# Access Compliance Report

## Public Rights-of-Way

### (Curb Ramps)

Intersection ID: 10031661	Main Street: MELODY_WOODS_CT	Cross Street: N/A	Location: SW
ADA ID: A091C8909FBF	Ramp Type: Perp	Initial Pass/Fail: Pass	Overall Compliance: No
Severity Score: 25.25			
Codes/Mitigation Info/Possible Solution		Field Measurements/Component Compliance

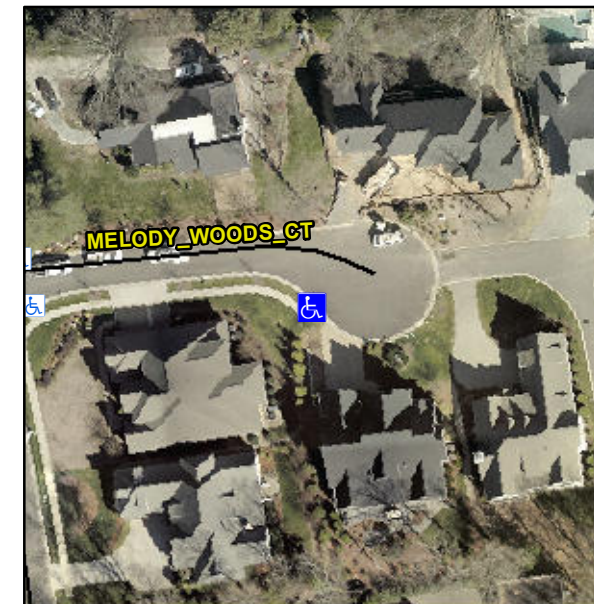
**Not Found, R304.5.3, R304.2.3,  
R305.2, R302.7.2, R304.5.4**

Compliance	Description	Data	Compliance	Description	Data
N/A	Ramp Length (in)	58.0	Yes	Ramp Slope (%)	7.3
Yes	Ramp Width (in)	48.0	Yes	Ramp XSlope (%)	2.1
N/A	Flare Type LT	Sloped	N/A	Flare Type RT	N/A
N/A	Flare Slope LT (%)	4.1	No	Flare Slope RT (%)	13.4
N/A	Flare Traversable LT?	Yes	N/A	Flare Traversable RT?	Yes
Yes	Landing Length (in)	48.0	Yes	DWS Provided?	Yes
Yes	Landing Width (in)	48.0	Yes	DWS Contrast?	Yes
Yes	Landing Slope (%)	0.3	Yes	DWS Length (in)	24.0
No	Landing X Slope (%)	4.8	Yes	DWS Full Width?	Yes
N/A	Landing Curb? (Y/N)	No	No	DWS Offset (in)	7.0
N/A	Shared Landing?	No			
Yes	Gutter Ponding?	No	No	Gutter Slope (%)	14.3
No	Gutter Lip Ht (in)	1.0	No	Gutter X Slope (%)	2.8
N/A	Painted X Walk1?	No	N/A	Painted X Walk2?	N/A
	X Walk 1 Direction	To NE		X Walk 2 Direction	N/A
N/A	X Walk 1 Width (in)	N/A	N/A	X Walk 2 Width (in)	N/A
	X Walk 1 Slope (%)	4.4		X Walk 2 Slope (%)	N/A
	X Walk 1 X Slope (%)	2.7		X Walk 2 X Slope (%)	N/A

N/A	Ramp inside XWalk1?	N/A	N/A	Ramp inside XWalk2?	N/A
	Road Slope (%)	N/A	N/A	Clear Space?	Yes
	Road X Slope (%)	N/A	N/A	Clear Space to XWalk (in)	N/A
Yes	Any Obstructions?	No	Yes	Storm Grate/Utility Hazard?	No
	Obstruction Type			Storm Grate/Utility Type	
		N/A			N/A
			Yes	Surface Condition? (G/P)	Good

**Remove & Replace Entire Ramp.  
Remove & Replace Gutter.**
